## Conditions of Approval

### Prior to Release Requirements

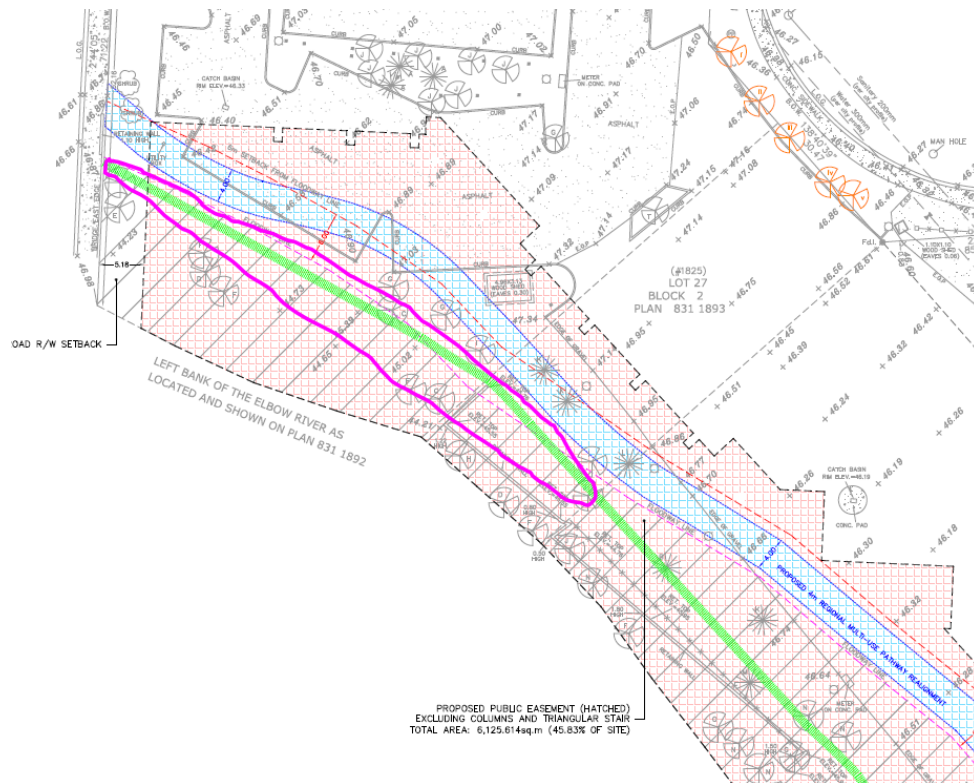
29. Remit payment (certified cheque, bank draft) for the proposed infrastructure listed below within the public right-of-way to address the requirements of the Business Units. The amount is calculated by the respective Business Unit and is based on 100% of the estimated cost of construction.
